Ricardo – Feedback on JRC proposals for use-phase concept; proposed revisions *update*

IWG Automotive LCA, SG4 – Use Phase 4th Meeting, WebMeeting, 10 October 2023

Draft CO₂eq Calculation (JRC)**

Fuel Consumption/Efficiency

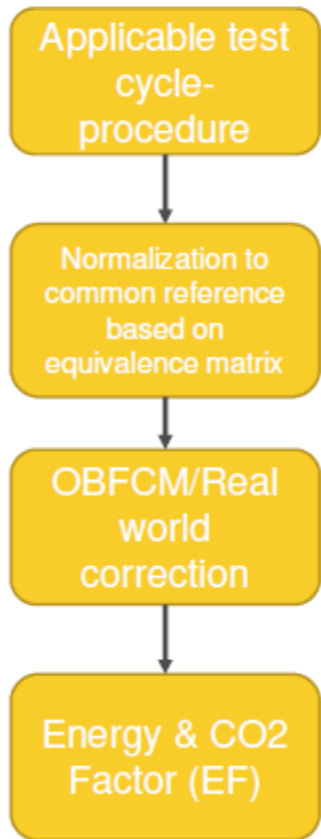
Ideal situation – may be practically difficult to achieve... also question if really needed...
